# Eskew Dumez Ripple<sup>+</sup>

## **ADDENDUM NO. 1** 01/09/2026

**RE:** Odenheimer Phase 1  
EDR Project No. 22071

**FROM:** Eskew+Dumez+Ripple  
400 Lafayette Street, Suite 300  
New Orleans, Louisiana 70130  
(504) 561-8686

**1 FLOOR PLAN - PLUMBING - KOMODO**

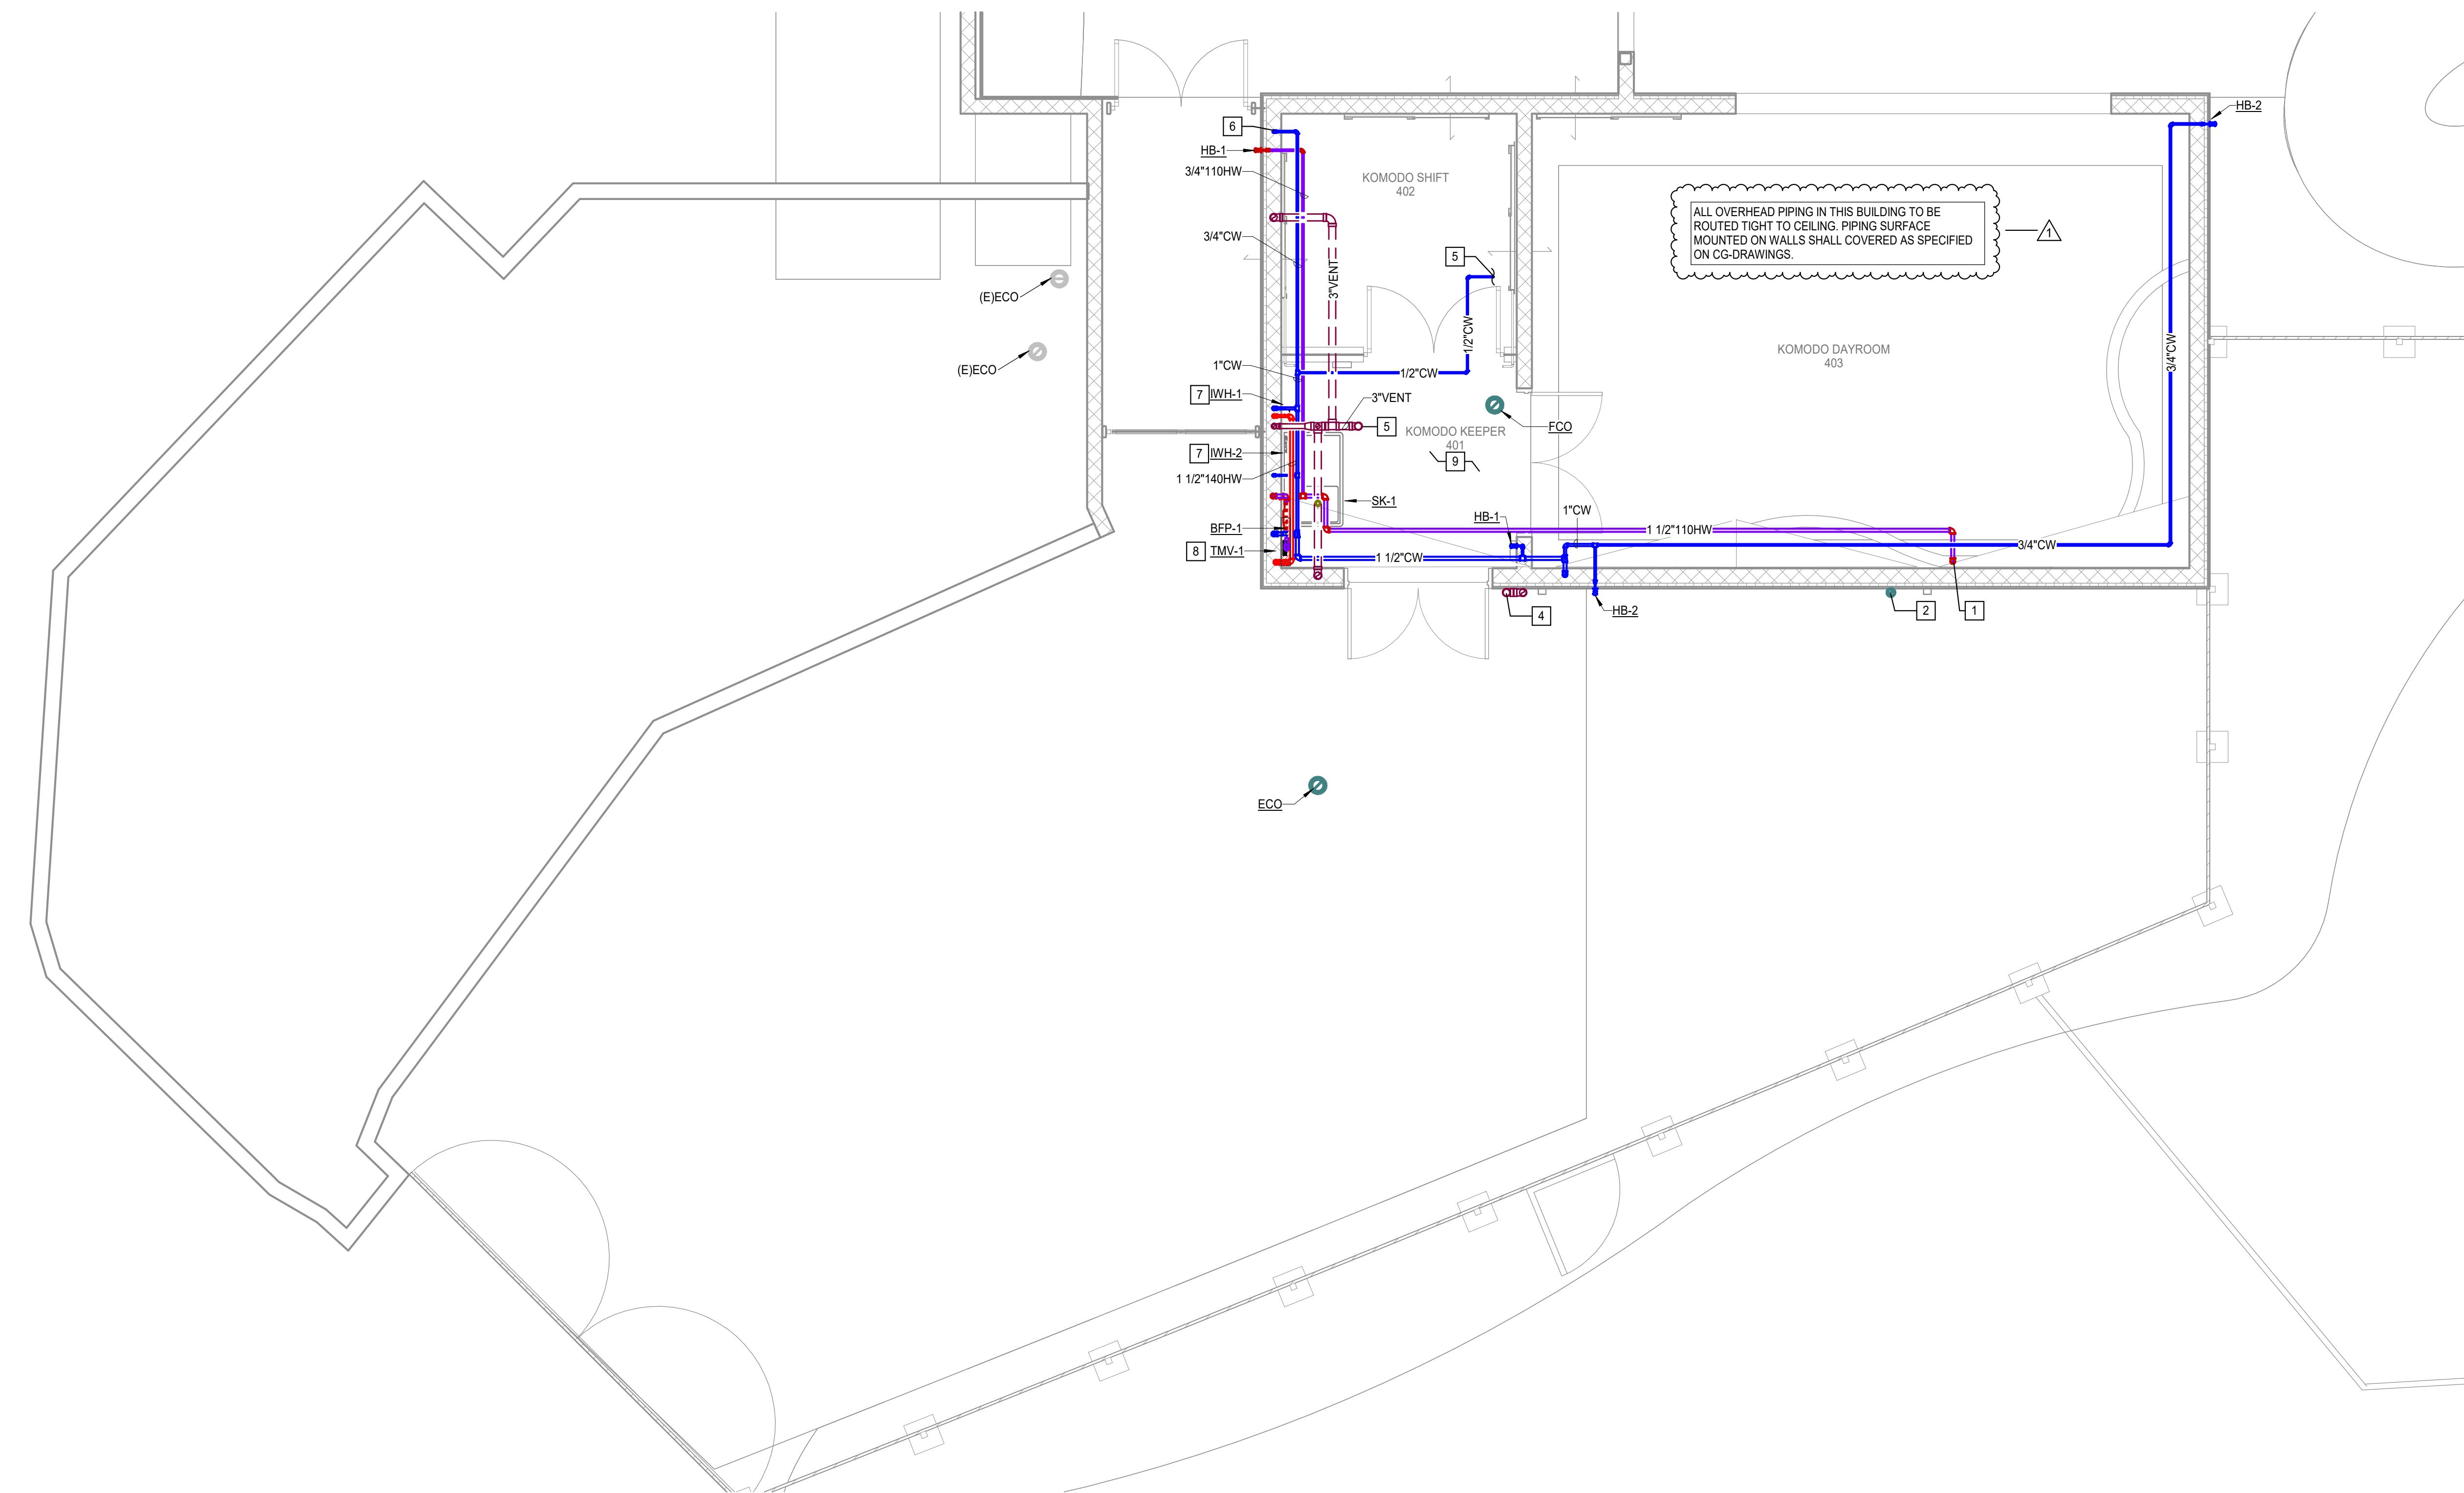
31. SHEET P2.3 – Revised note about pipe routing in Komodo exhibit
